UNITED STATES PATENT AND TRADEMARK OFFICE

APPLICATION NO.	FILING DATE	FIRST NAMED INVENTOR	ATTORNEY DOCKET NO.	CONFIRMATION NO.
10/500,191	06/25/2004	Masahiro Sano	Q82273	9237
23373 7590 12/03/2007 SUGHRUE MION, PLLC 2100 PENNSYLVANIA AVENUE, N.W. SUITE 800 WASHINGTON, DC 20037			EXAMINER KNABLE, GEOFFREY L	
			ART UNIT 1791	PAPER NUMBER
			MAIL DATE 12/03/2007	DELIVERY MODE PAPER

Office Action Summary	Application No. 10/500,191	Applicant(s) SANO, MASAHIRO	
	Examiner Geoffrey L. Knable	Art Unit 1791

(PRIOR ART)
Fig. 2

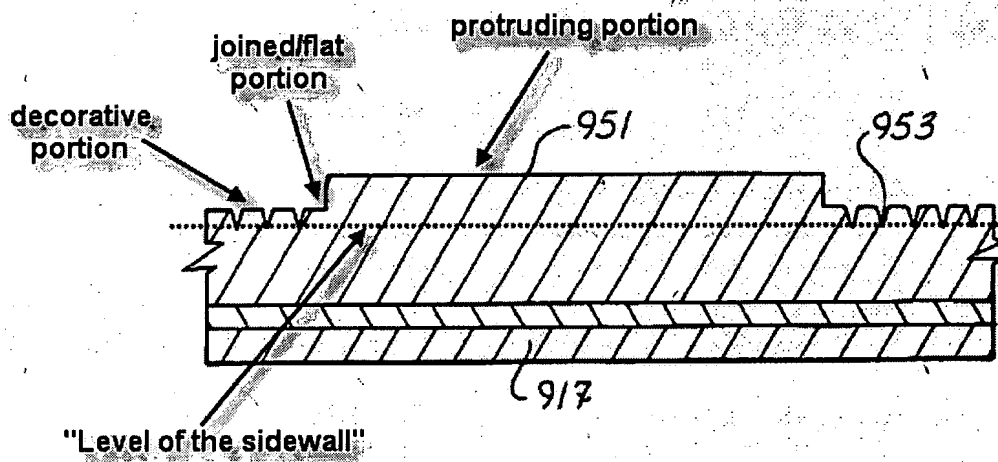
As to claim 1, Kemp et al. is applied for substantially the same reasons as set forth in the last office action. As to the new requirement that tops of the decorative portion protrude higher than a level of the sidewall, note the marked up figure 2 which has been further marked to show why this is still considered to be met:

Note that the tops of the decorative portion protrude higher than what is considered the level of the sidewall. A tire as required by claim 1 is therefore anticipated by this disclosure. As to the new requirement in claim 3 that the flat portions are provided between protruding portions, given that the tire includes multiple letters (which are the protruding portions - note fig. 1), the indicated flat portion would be located between protruding portions for areas between letters. A tire as required by claim 3 is therefore still considered to be anticipated by this disclosure as well. As to claims 9-12, note that the protruding portions comprise letters and the adjacent serrated portion does not comprise letters.

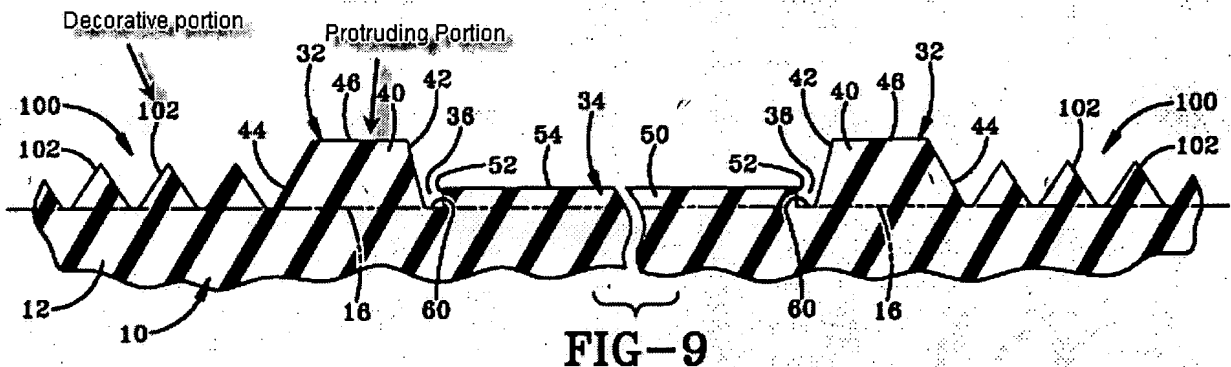
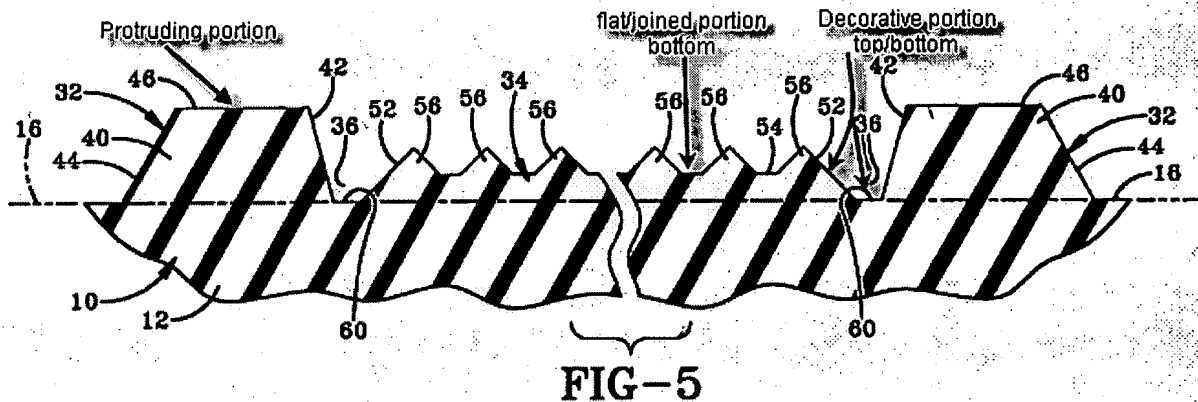
Vizina discloses a tire including a sidewall having a serrated background pattern (e.g. note various cross-sections) defining what is considered to be a decorative portion having interconnected tops and bottoms in the protruding direction; the bottoms of the serrations being reasonably considered a "level of the sidewall" from which the serrations protrude. Further, protruding portions higher than the tops of the decorative portions are provided in the pattern (esp. fig. 5) with a flat portion between adjacent protruding parts (i.e. the flat part between each of the two raised portions in fig. 5) being higher than the bottoms of the decorative portion (e.g. note again esp. fig. 5). This reference is therefore considered to anticipate what is defined in claim 3, the ambiguities already noted however preventing a complete and accurate comparison, any differences however being considered obvious optimizations of this basic teaching. As to claim 4, the parts between adjacent protruding parts are flat and can be said to

suggest or render obvious the claim 4 relative dimensions reading the dimension of the protruding ends as being from for example the outer ends thereof. As to claim 7, the illustrated relative dimensions are considered to suggest or certainly render obvious relative heights within the broadly claimed range, it being stressed that the illustrated design being a design patent would have been read to be a more accurate representation of how the final structure should be relatively configured. As to claims 11 and 12, note that the protruding portions define a group of letters "L" (fig. 2) while the serrated decorative portion does not comprise letters.
